Date: December 23,2025
Project:: Voyage
898 E Washington st
Orlando, FL
Letter type: Architect letter - ADA Variance

FLOOR PLAN - 1ST FLOOR

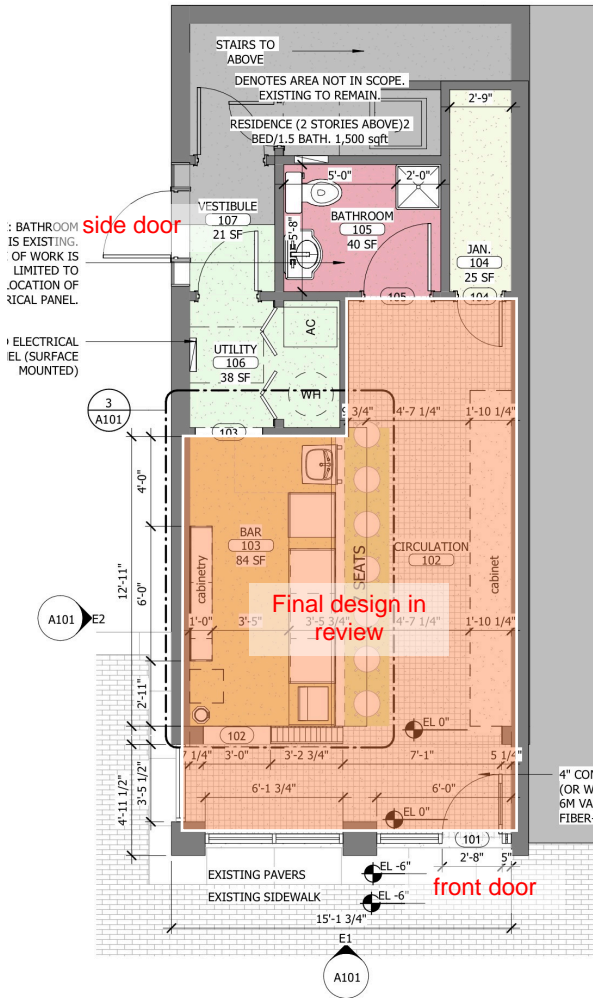
1. **Non-Viable Front Entrance ADA Ramp:** Providing compliant ADA access at the main entrance is not feasible. The 6-inch height differential necessitates a 16-foot-long ramp system (6-foot ramp run plus two 5-foot landings), which cannot be accommodated due to existing structural limitations and potential encroachment onto the public sidewalk.
2. **Structural Constraints on Side Door ADA Access:** Compliance for ADA access at the side door is unachievable due to insufficient hallway width. The existing walls, which house the laundry area, are outside the current scope of work and present an unresolvable structural limitation.
